Prairie Island Nuclear Generating Plant Units 1 and 2
Dockets 50-282 and 50-306
License Nos. DPR-42 and DPR-60

Response to NRC Request for Additional Information Regarding Application for Renewed Operating Licenses

Enclosure 1
Response to Follow-up RAI B2.1.38

Figure 1 Weight Loss in Acid vs. Volume Fraction of Cement (based on data from Reference 7)

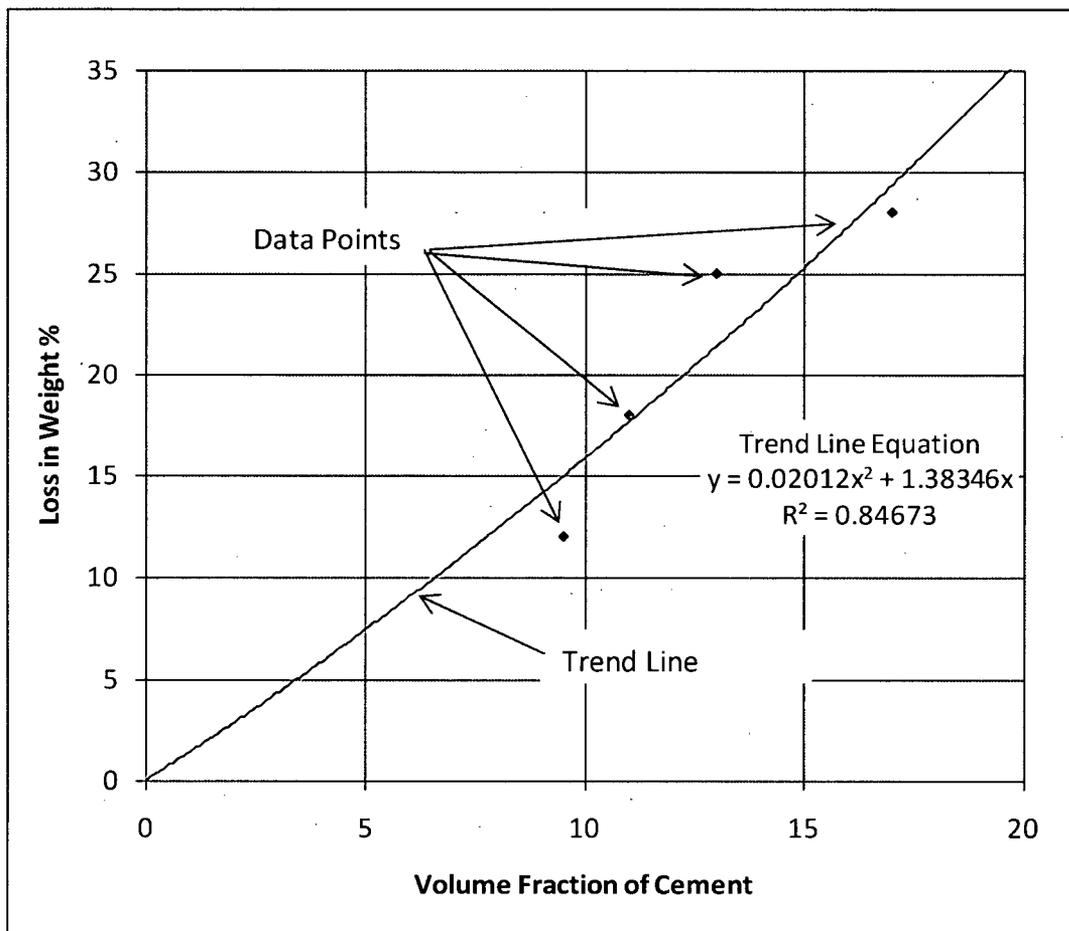
- e) Section 5.2.6 of Reference 1 states, "...concrete is not relied upon for tensile strength (tensile strength provided by rebar)." Please explain how formation of large thru thickness cracks will affect the transverse shear capacity of concrete slabs and walls. Shear strength of concrete is directly related to the tensile strength.

Quantitative data in Reference 7 for weight loss of concrete cubes when exposed to an acid concentration of 3% is shown in Figure 1. A trend line is shown on the figure that provides an equation for quantifying this dissolution behavior. As can be seen, the weight loss increases somewhat more strongly than linearly as the volume fraction of cement, (i.e., of soluble material), increases.

A footnote on page 10 of Reference 4 indicates that concrete normally contains 10 to 15% of cement, or an average of about 12.5%. As noted on page 2-2 of Reference 1, the amount of carbonaceous aggregate in the concrete used at Prairie Island was about 5%. Adding this 5% to the average 12.5% cement results in a total of 17.5% soluble material in the concrete at Prairie Island as compared to the 12.5% in a concrete with all igneous (no carbonate) based aggregate such as was used at the cited plants. (Section 8.1.3 of Reference 8) Using the trend line equation shown in Figure 1, increasing the fraction of soluble material (cement in the figure, cement plus soluble aggregate in this case) from 12.5% to 17.5% increases the weight loss by a factor of 1.49. This indicates that the assumed factor of 2.0 increase in severity of acid attack to account for the presence of 5% carbonate-based aggregate is conservative by a significant margin (2 vs. 1.49).

General Arrangement of Change Fixture Supports

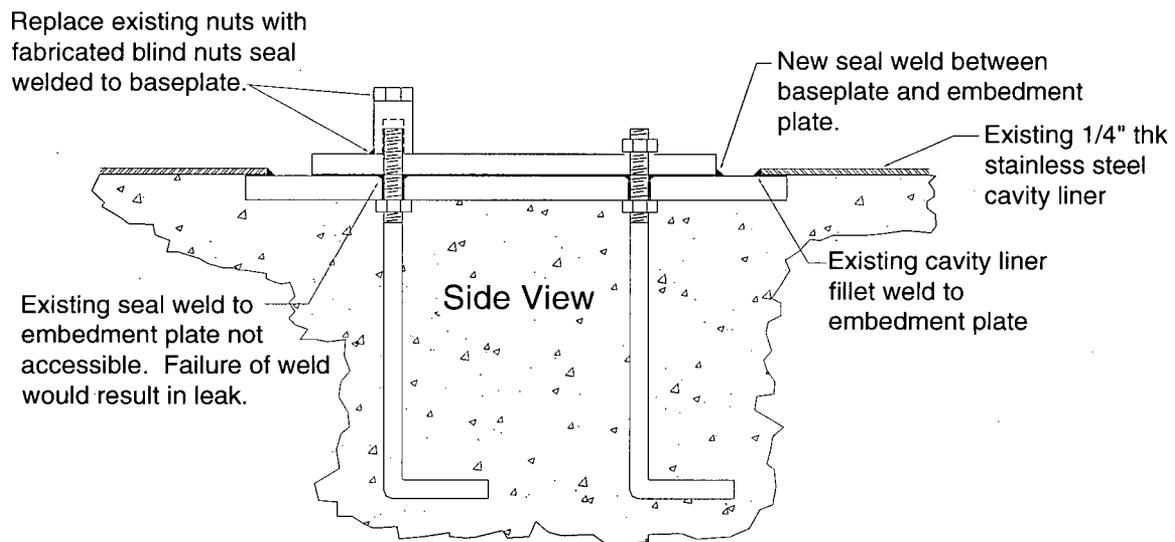
- i) Page 52 of Reference 2 identified five recommendations to address reactor cavity leakage. Please provide NSPM's action plan and schedule for completing these five recommendations.

The RCE concluded that the most likely refueling cavity leakage points are where the anchor studs for the reactor internals stands and the Rod Control Cluster (RCC) Change Fixture penetrate the associated embedment plates. The studs for these fixtures pass through holes in the embedment plates and are seal welded on the underside for the internals storage stands, and on top (then ground flush) for the RCC Change Fixture. Pinhole leaks or small cracks in one or more of the seal welds would result in a leak path through the embedment plate along the threads of the studs, allowing water under the cavity liner.

The plant management review of the Root Cause Evaluation considered the value, need and sufficiency of each recommendation. The current repair plan that emerged from these reviews is to replace the existing anchor nuts with new fabricated blind nuts that are seal welded to the existing baseplates. In addition, the existing baseplates will be seal welded to the embedment plates. The new welds will be readily accessible for examination to ensure the existing anchors and baseplates are leak tight. The following sketch depicts a typical RCC change fixture support showing the planned repairs. Similar repairs will be made to the internals stands supports.
